r. SEEBURG CORPORATION . 1500 Dayton St., Chicago 22, Illinois

August 15, 1956 Bulletin DC56-32

Attached is a diagram showing a modification of the 2D21 test adapter given with our Bulletin DC56-31 of August 8. In this modification a 10 ohm and a 0.56 ohm resistor replace the 0.47 ohm resistor. It is recommended that test adapters having the single resistor be changed to include the two resistors and that any adapters made henceforth be set up in accordance with this new diagram.

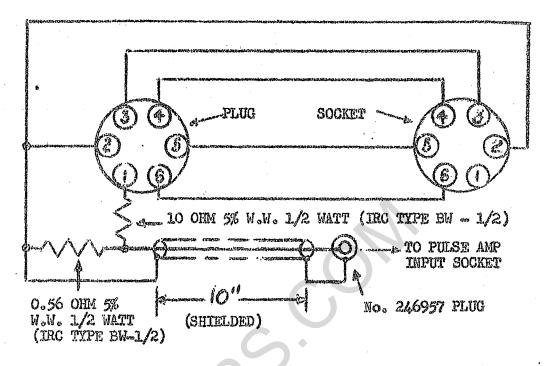
The change is necessary to overcome a condition found in some of the pulse amplifiers in which there is an "over-shoot" when associated with a 2D21 tube that is unusually hot. The over-shoot causes the pulse amplifier to turn on and immediately turn off again so the net result is the same as though the 2D21 is weak or not acceptable.

The problem with the pulse amplifier is associated only with the adapter and the test of the 2D21's in which an unusually high amplitude pulse can be fed into the amplifier. It should not be confused with normal operation in any way because the amplifier displaying the unusual condition will function properly in normal selection operation.

The resistors for the modified adapter circuit are not used any place in our normal equipment and for that reason are not available from our Parts Department. They may be had from any radio parts supplier carrying a reasonably complete stock for they are standard RETMA values. It is recommended that only the wire-wound types be used. It is also recommended that the shielded lead of this adapter be held to not more than 10" length and that a low capacitance type be used. If the lead is too long or is of high capacity, it will seriously attenuate the pulse to the pulse amplifier and effectively change the operational characteristics so that tubes that are still useable will be rejected. If there is any doubt of the type of shielded wire you have available, you may order the No. 95106, vinyl covered, single conductor cable, available from our Parts Department.
